# Stage 2 & 3 Site 3 – Australia Towers Sydney Olympic Park

Section 75W - MOD 4  
Environmental Assessment Report

July 2014

FIGURE 2 – GROUND FLOOR PLAN

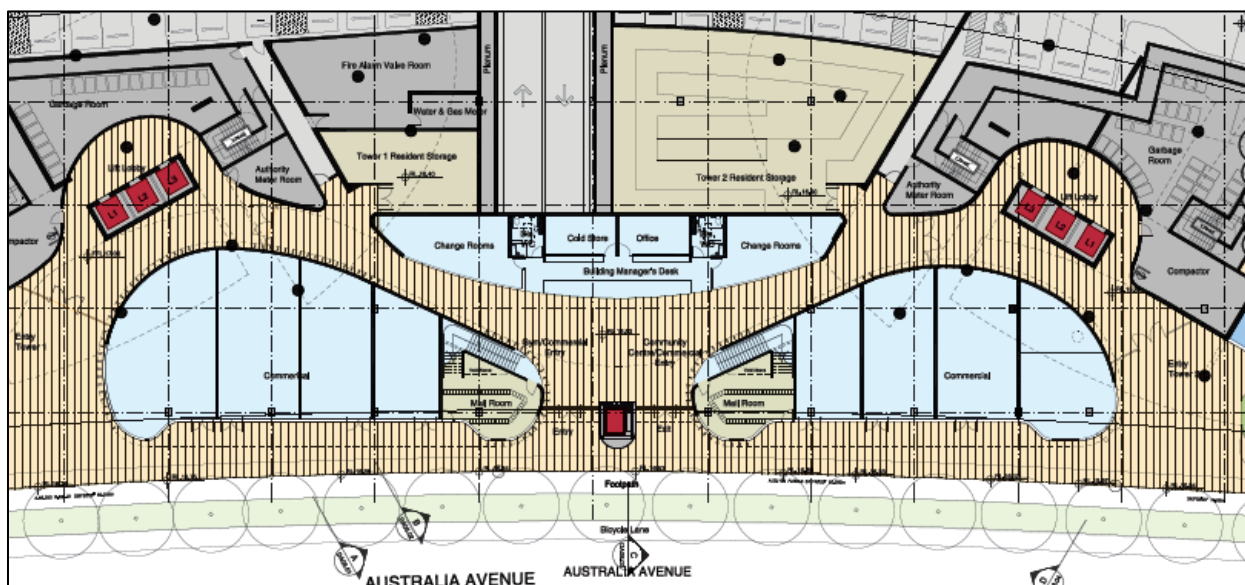
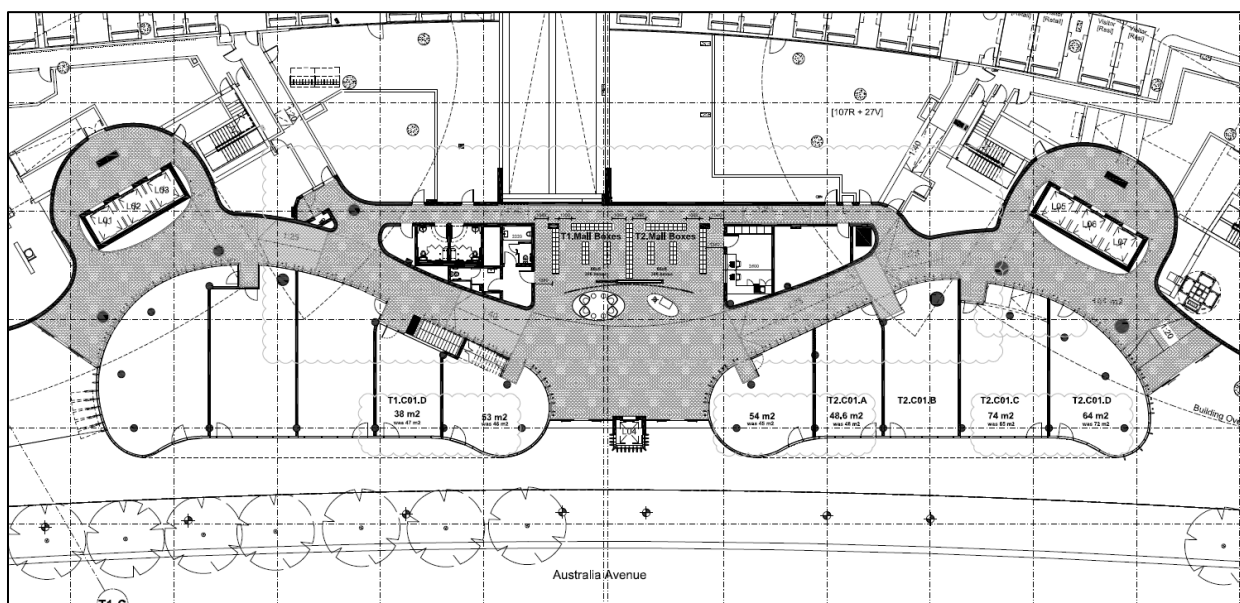
- Relocation of the mail rooms on the ground floor level and reconfiguration of the change rooms.
- Conversion of the existing mail rooms to commercial space. There is also an increase in the size of some of the commercial tenancies;

LEVEL	MODIFICATION
Ground level	Reconfigure change rooms, mail rooms and commercial tenancies.
Level 24	<p>Tower C:</p> <ul style="list-style-type: none"><li>▪ Convert part of the plant space to one x 2 bedroom unit and one x 3 bedroom unit.</li><li>▪ Minor internal reconfiguration of studies and storage areas.</li></ul>
Level 30	<p>Tower D:</p> <ul style="list-style-type: none"><li>▪ Converting some of the plant room space to one x 3 bedroom unit with study and balconies.</li><li>▪ Increase size of indoor communal area and reconfigure outdoor communal area.</li></ul>

FIGURE 3 – LEVEL 24 – TOWER C

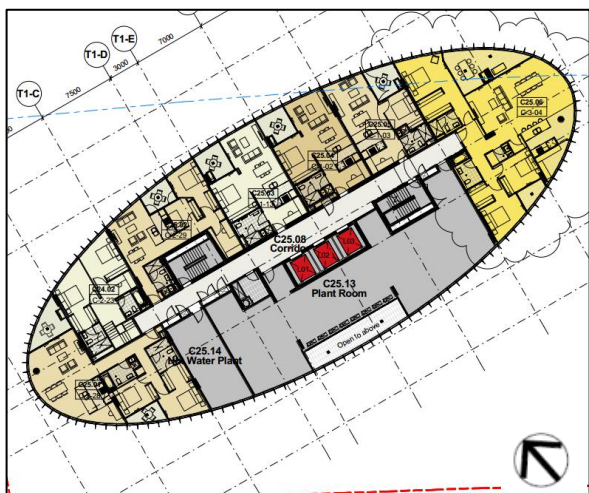
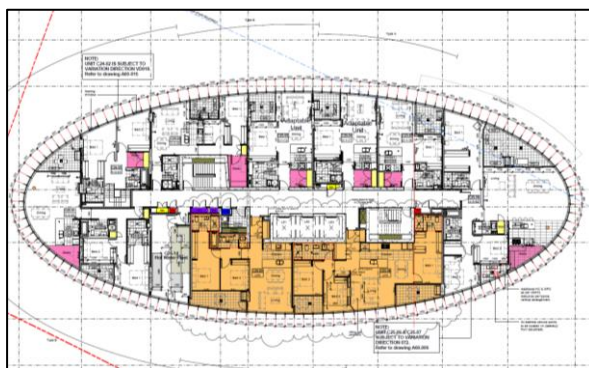
- Convert the plant area on Level 24 of Tower C to two new residential apartments;
- Minor internal reconfiguration of studies and stores on Level 24 of Tower C;

FIGURE 4 – LEVEL 30 – TOWER D

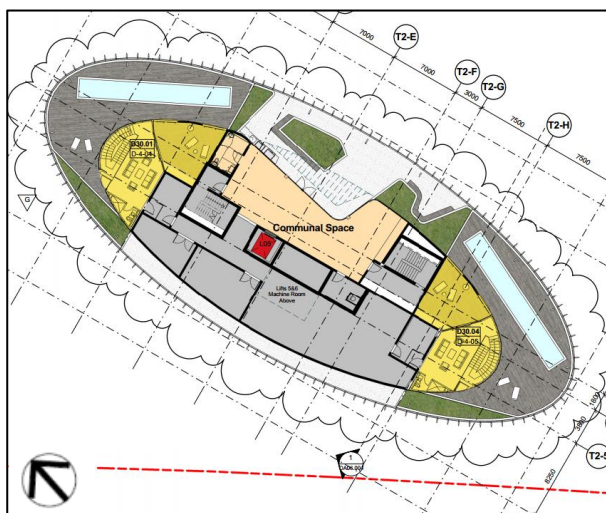
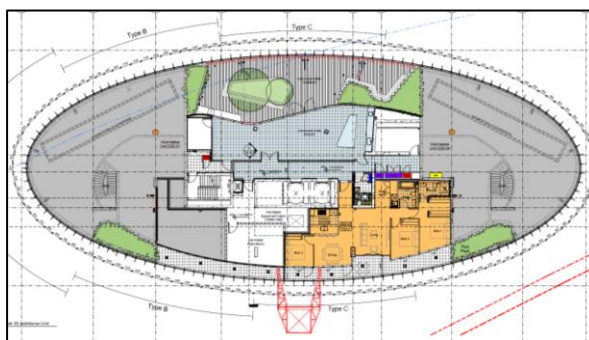
- Convert the plant area on Level 30 of Tower D to one new residential apartment, relying on approved lift access to roof level;
- Reconfiguration of communal area (indoor and outdoor) with new landscaping design;

- A modification is proposed to the roof top communal area to increase the size of the indoor space. There will be a reduction in outdoor communal space, however the change is justified in order to provide more space for year round use.

- The reconfiguration of the common roof top space will improve the amenity for all occupants of Stages 2 and 3 towers, who have access to this space. The indoor space is of a size that can accommodate gatherings for meetings, events and celebrations.
